1988 - 1989 Corvette: Recall Notice: Rear Wheel Tie Rod

Bulletin No: 89C17

Subject: PRODUCT SAFETY CAMPAIGN 89C17
REAR WHEEL TIE ROD

Model and Year: 1988-89 CHEVROLET CORVETTE

FIGURE 1

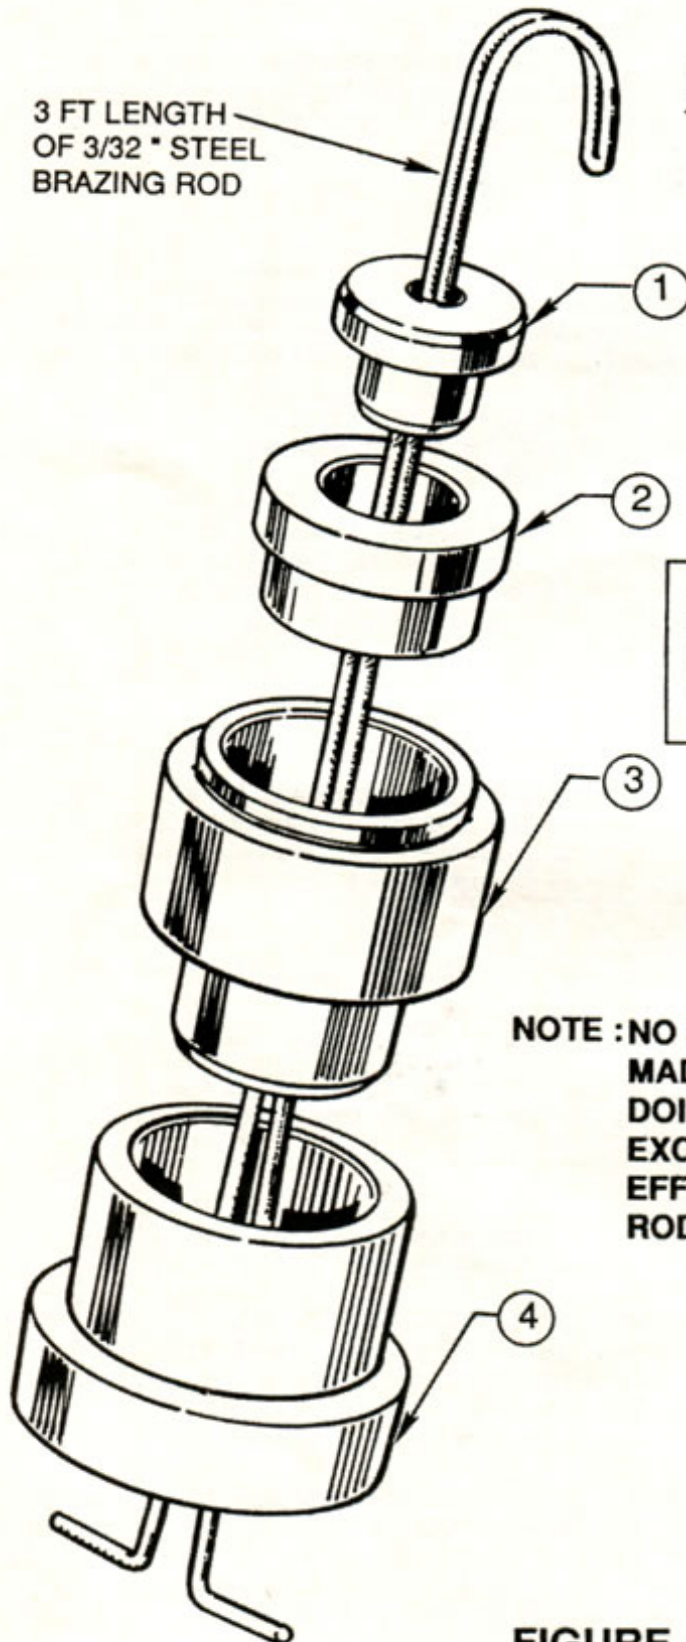
1. Fabricate/Assemble weight from materials indicated and as illustrated in Figure 1.
2. Raise Vehicle.
3. Remove cotter pins, nuts and washers from both outer rear tie rod ends and disconnect from knuckle assemblies utilizing tool J-24319-01.

**NOTE : NO SUBSTITUTIONS SHOULD BE
MADE FOR THE TOOLS INDICATED.
DOING SO, MAY RESULT IN AN
EXCESSIVE WEIGHT WHICH COULD
EFFECT THE ACCURACY OF TIE
ROD INSPECTION.**

FIGURE 2

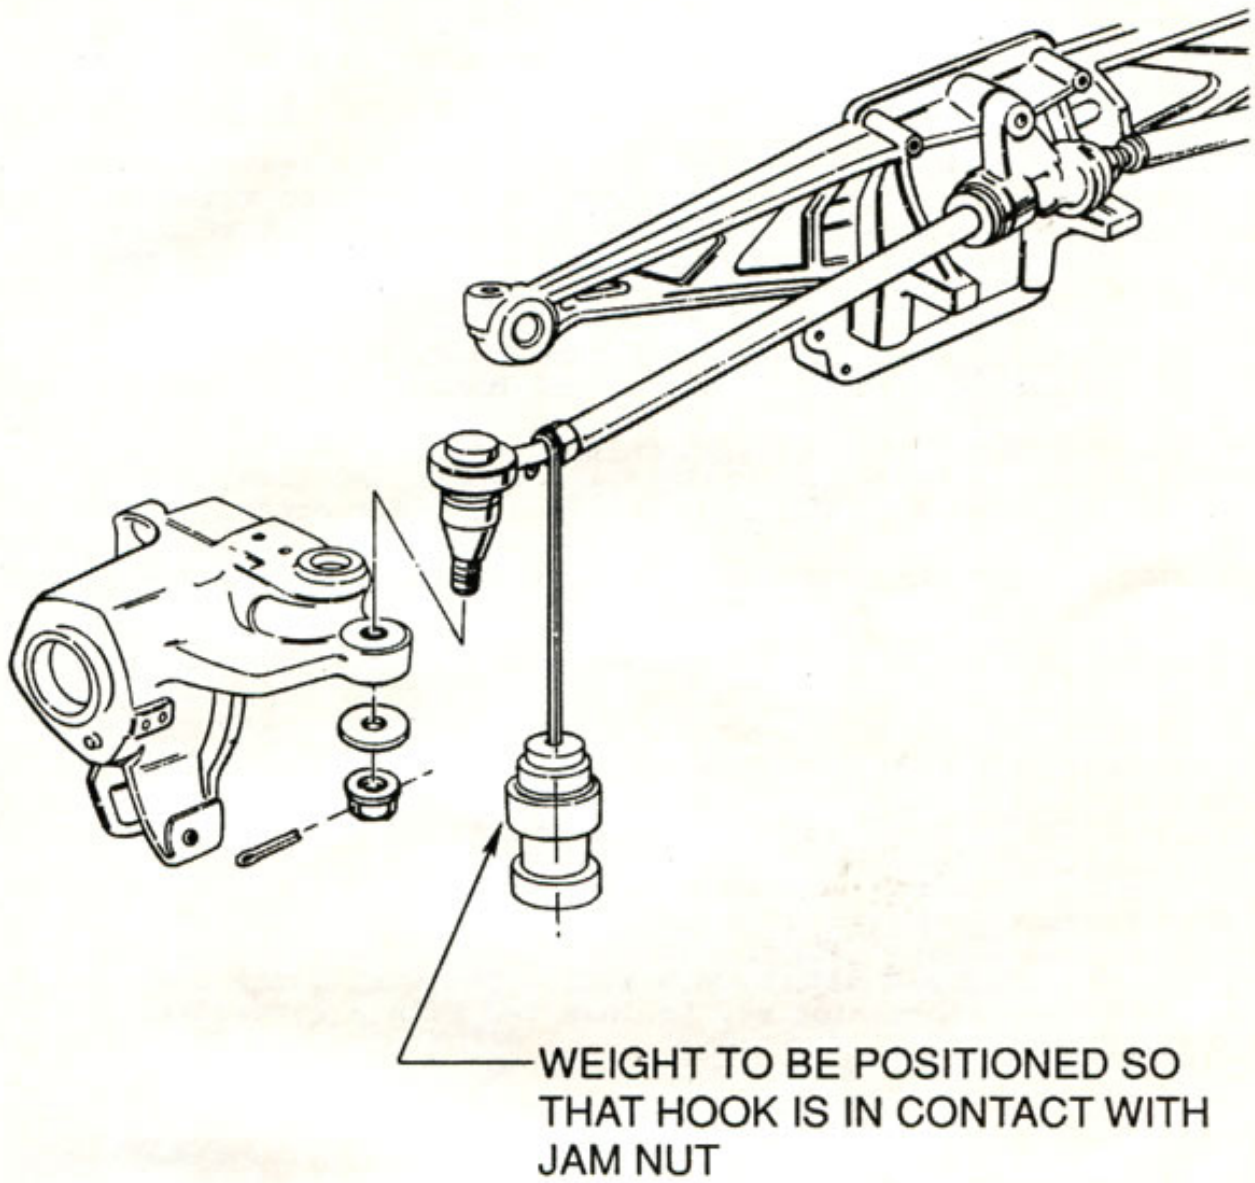
4. Raise and hold outer end of left hand tie rod linkage in its upper most position, insuring rod is not rotated while being raised. Attach weight as shown in Figure 2, release linkage and note results. Repeat procedure on right hand tie rod linkage.
5. Based on observations noted in performing step 4, select appropriate action from those noted below:
 - A. Linkage moves downward on both sides - Reconnect tie rod sockets to knuckles, install washers and nuts, torque nuts to 45 Nm (33 lbs. ft.) and install cotter pins.
 - B. Linkage on either or both sides doesn't move downward - Replace tie rod assembly, transferring existing tie rod ends to new assembly and following Section 3D in the Chevrolet Corvette Service Manual of the appropriate year.
6. Install Campaign Identification Label.
